Model: OP-P3/MF3	Date:4-Nov-16	No.: RM0A1001a
------------------	---------------	----------------

Subject: Launch of the new model OP-P3/MF3 (differences from the predecessor model)		Prepared by: Y.Miyamoto	
From: 1nd Tech Service Sect., MFP/Printer Tech Service Dept.			
Classification:	<input type="checkbox"/> Troubleshooting	<input type="checkbox"/> Part information	<input type="checkbox"/> Action required
	<input type="checkbox"/> Mechanical	<input type="checkbox"/> Electrical	<input type="checkbox"/> Service manual revision
	<input type="checkbox"/> Paper path	<input type="checkbox"/> Transmit/receive	<input type="checkbox"/> Retrofit information
	<input type="checkbox"/> Product Safety	<input checked="" type="checkbox"/> Other (New model)	<input checked="" type="checkbox"/> Tier 2

This bulletin announces the differences between the new model OP-P3/MF3 and its predecessor model OP-P2/MF2. As you are probably aware, an FSM exclusively for the new model will not be released. Please refer to the FSM of the predecessor model and this bulletin when servicing the OP-P3/MF3.

Important Safety Notices (pg.5)

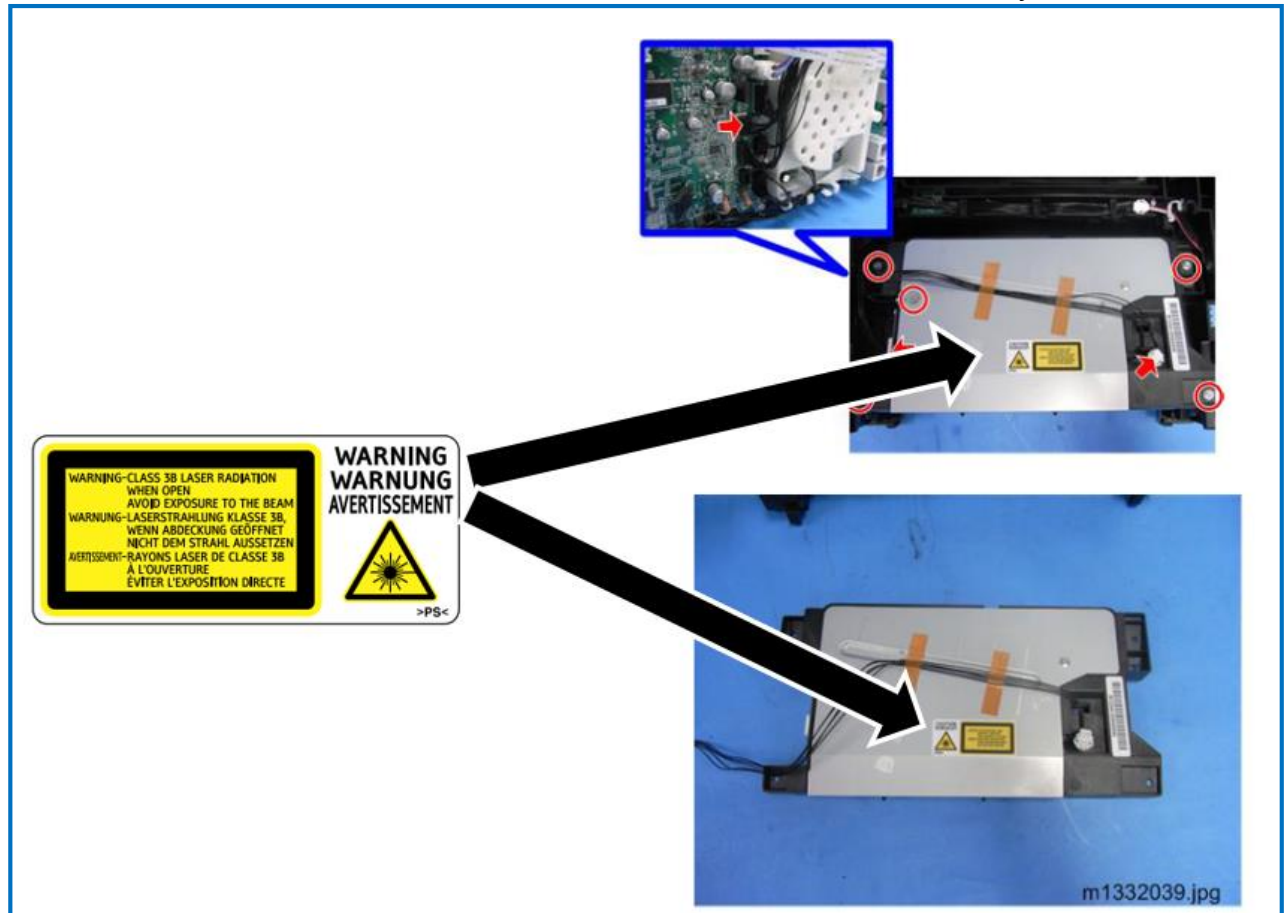
The laser caution decal was modified in line with the revised laser safety standard.

4. Replacement and Adjustment > Boards > PSU (Pg. 89)

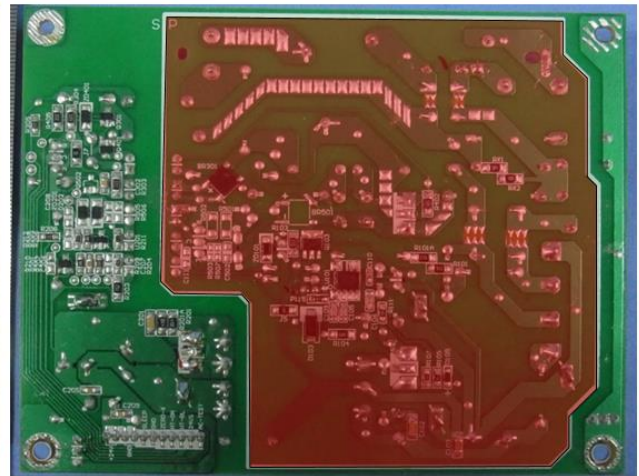
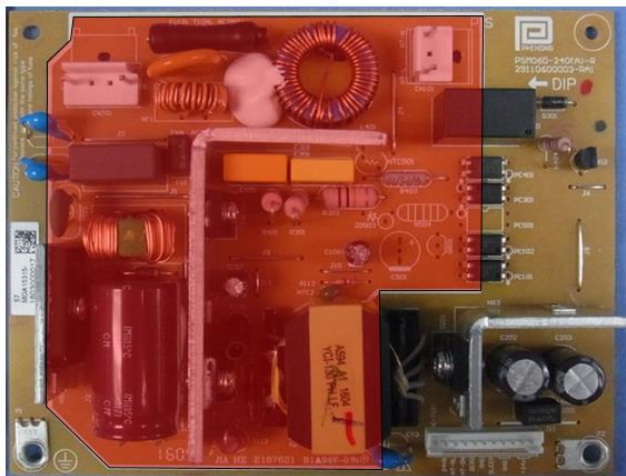
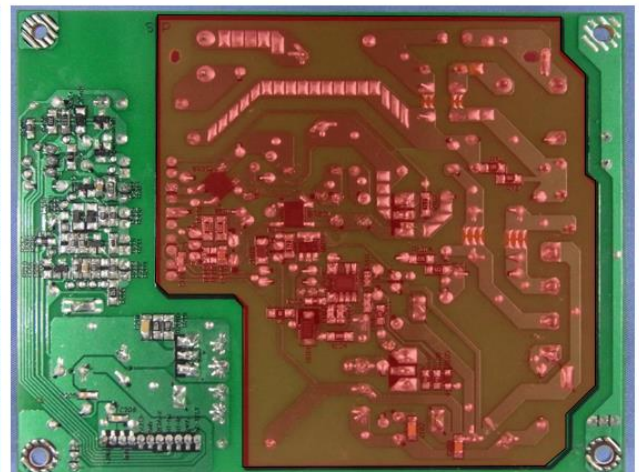
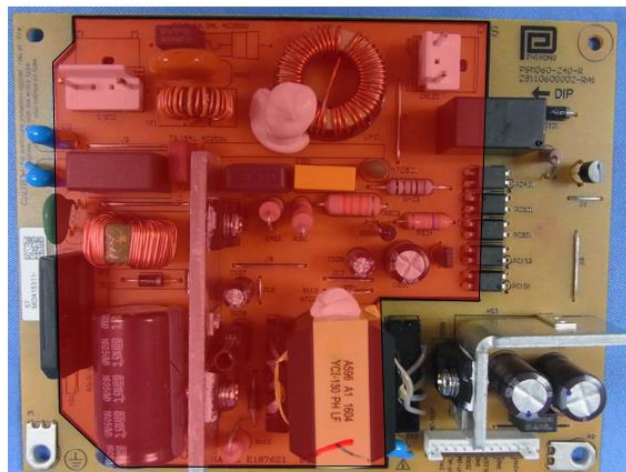
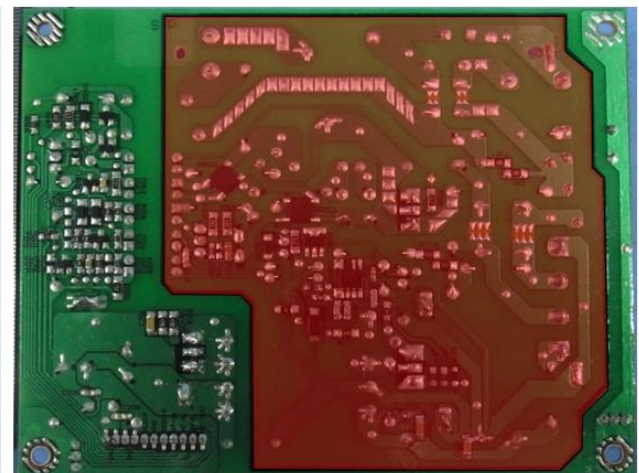
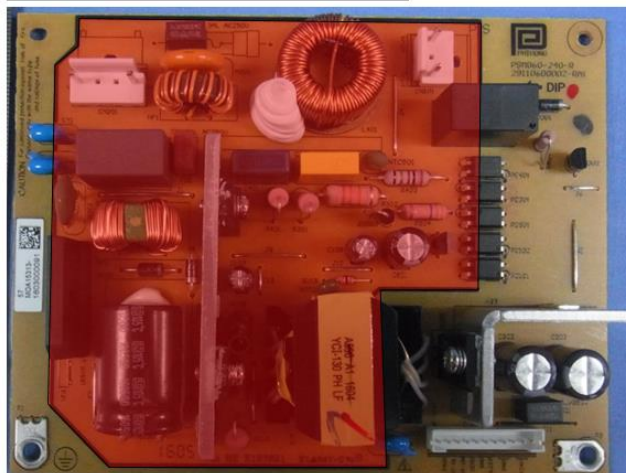
The following caution was added to the PSU replacement procedure.

NEVER touch the areas outlined in red in the photos below to prevent electric shock caused by residual charge.

Residual charge of about 100V-400V remains on the PSU board for several months even if the board had been removed from the machine with the machine power turned off and the power cord unplugged.
